Title <i>QPD Channel</i>			
Size: A	DCC Number: D1300650		<i>Ligo Project</i> <i>California Institute of Technology</i> <i>Massachusetts Institute of Technology</i> 
Drawn by: Ben Abbott	Date: 2/4/2014	Revision: v2	
File: C:\restored\Ben\AOS\TCS Stuff\TCS ISS Chassis\Interface Board\QPD\Title 2.5.0049 PM Sheet 2 of *

aLIGO TCS ISS
Interface Board
D1300650-v2

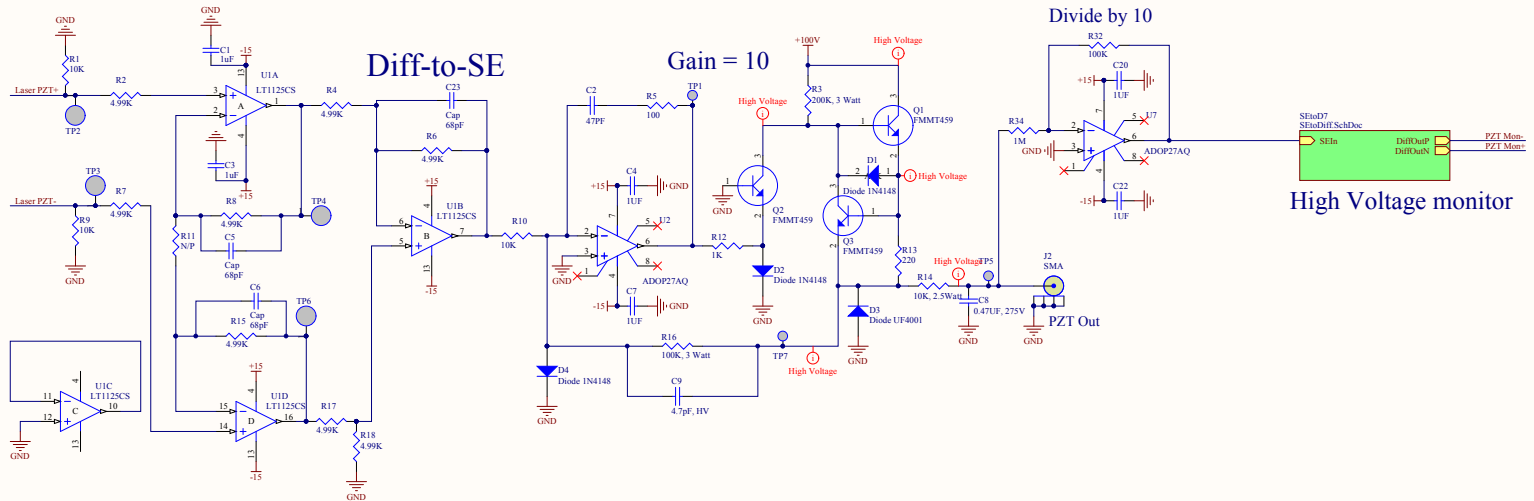
v2 changes the polarity of the PZT input to take into account the inherent reversal.
